- Subject** ▶ Standardization of the tool holder system to "SDS-MAX"
- For Models** ▶ HM1100, HM1100C (Demolition Hammers)
- Description** ▶ As illustrated below, the tool holder system has been changed to the system that accepts SDS-MAX bits only.

▶ Current	▶ New
 <p style="text-align: center;">Roller Guide</p>	 <p style="text-align: center;">Roller Guide</p>
 <p style="text-align: center;">Tool Holder</p>	 <p style="text-align: center;">Tool Holder</p>

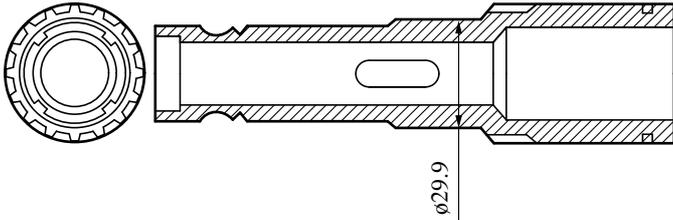
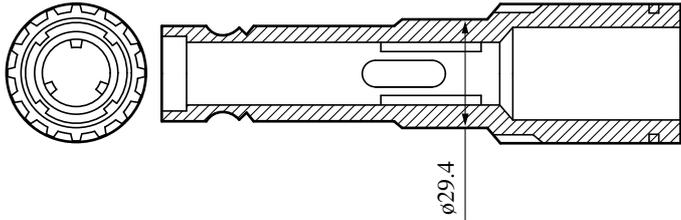
Inner diameter of Roller Guide is changed. Three projections is added in Tool Holder.

Item No.	Current part		Q'ty	I/C	New part		Q'ty	Note
14	Roller Guide 331484-4		1	No	Roller Guide 331504-4		1	Interchangeable as a set

HM1100: From serial No. 1248
 HM1100C: From serial No. 4354
